**VOLUME III  
FINAL ENVIRONMENTAL IMPACT STATEMENT  
CONSTRUCTION AND OPERATION OF  
TITAN IV/CENTAUR LAUNCH COMPLEX**

**VANDENBERG AIR FORCE BASE, CALIFORNIA  
AUGUST 1990**

**DEPARTMENT OF THE AIR FORCE**

FIGURE 2.1.11

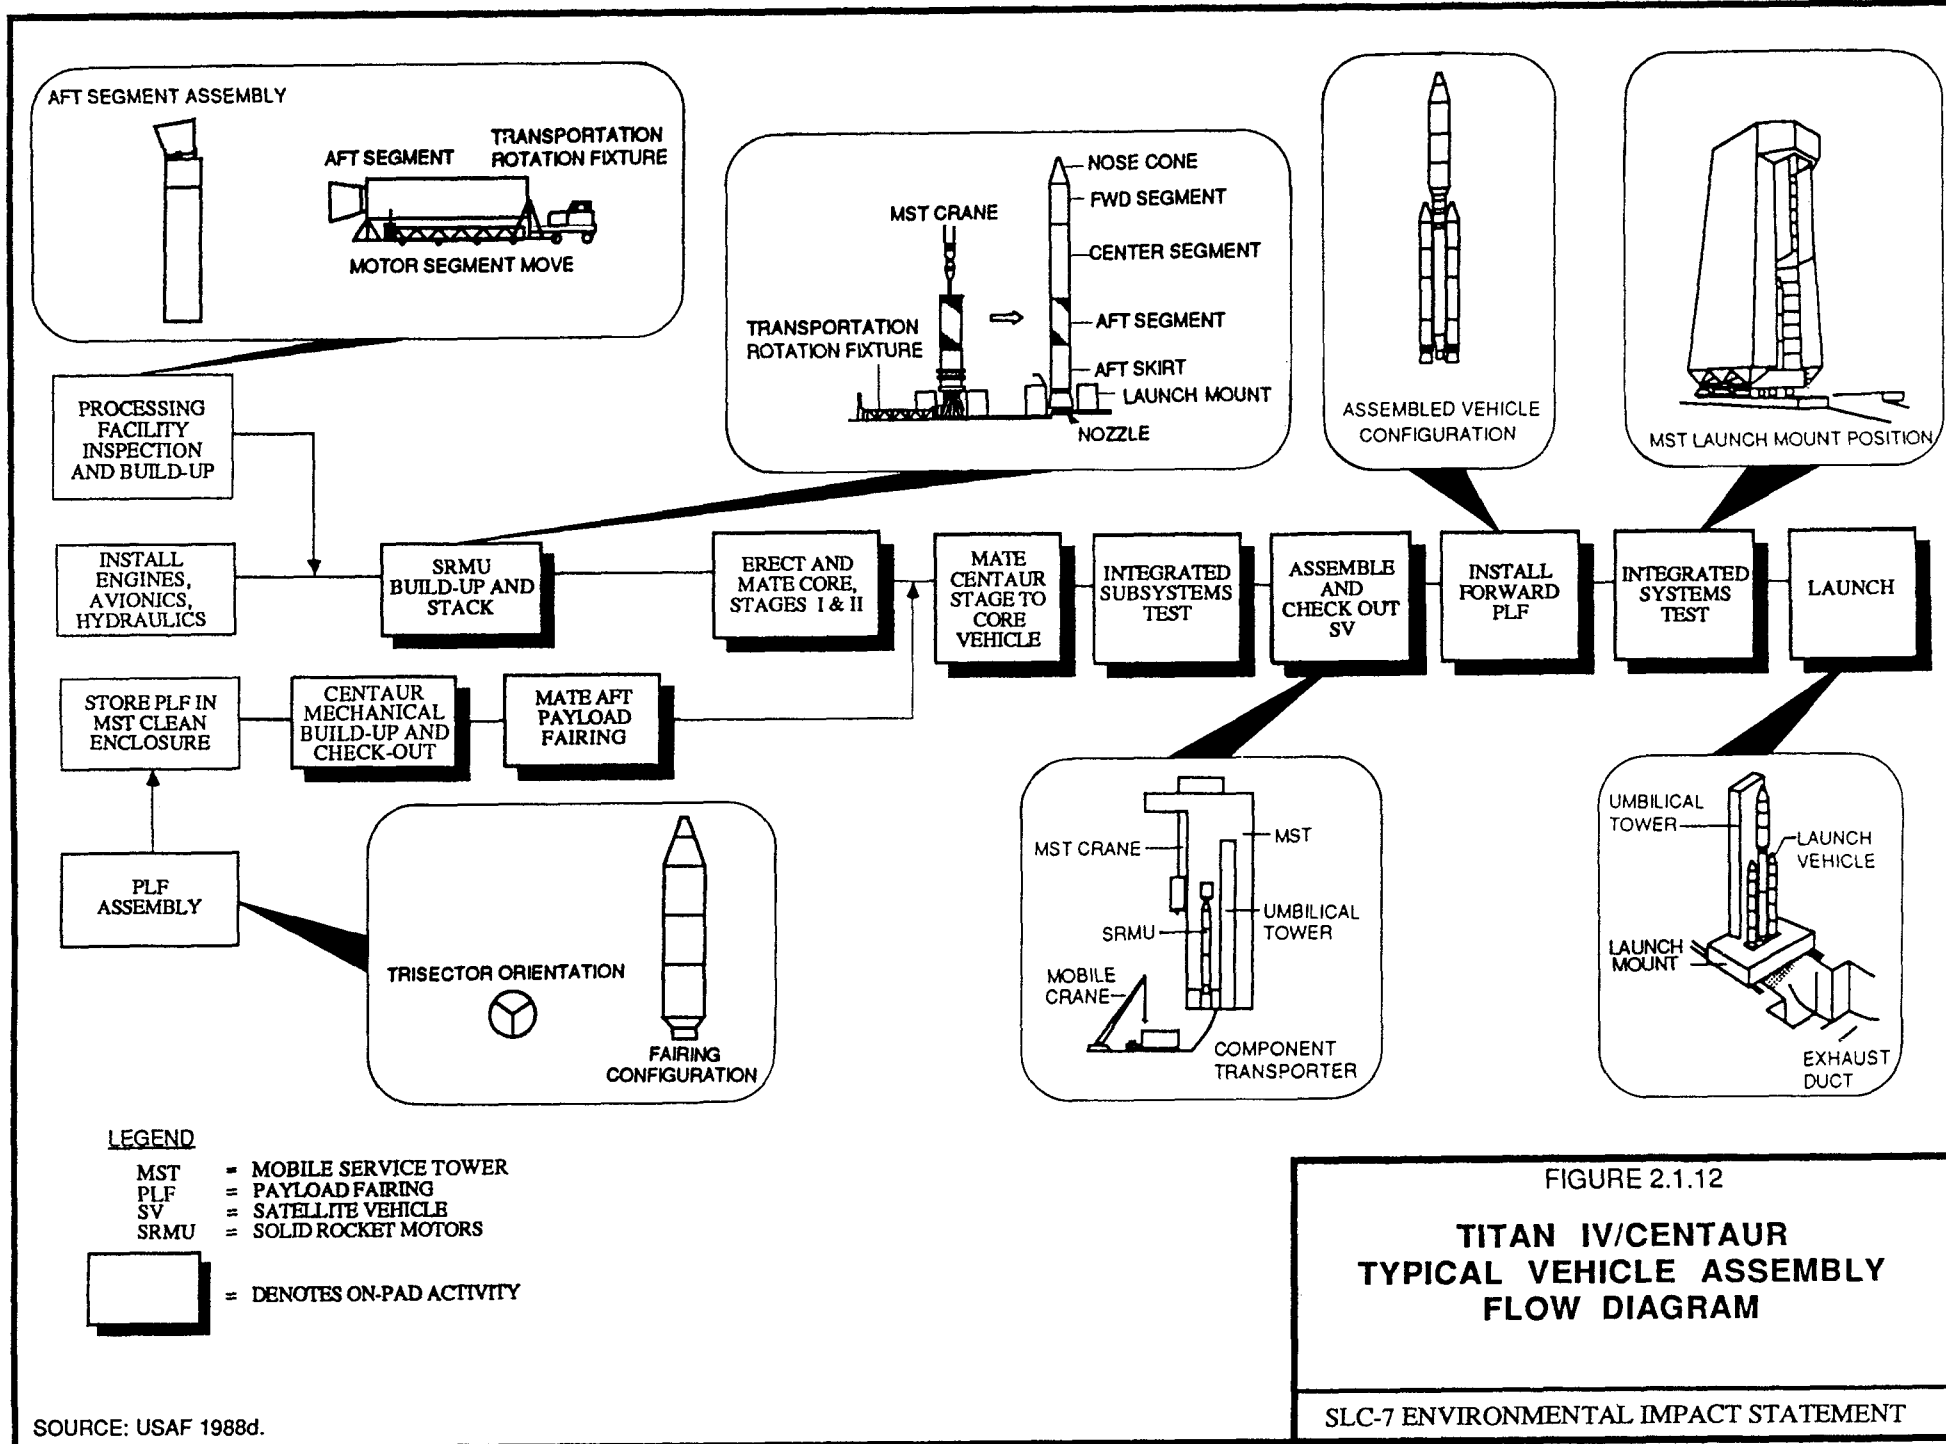
[44] Page 2-25 - More information is needed on the locations of the proposed borrow and spoil pits indicated in Figure 2.1.11. Borrow areas adjacent to the Santa Ynez River may contain riparian/wetland resources which could be impacted by borrow activity. This needs clarification.

The potential borrow pits adjacent to the Santa Ynez River are no longer being considered as areas that would be utilized as a source of construction material for the proposed action. A revised Figure 2.1.11 is provided in Section 3.3 of the Final EIS.

The potential borrow pits adjacent to the Santa Ynez River are no longer being considered as areas that would be utilized as a source of construction material for the proposed action. A revised Draft EIS Figure 2.1.11 is provided in Section 3.3 of the Final EIS.
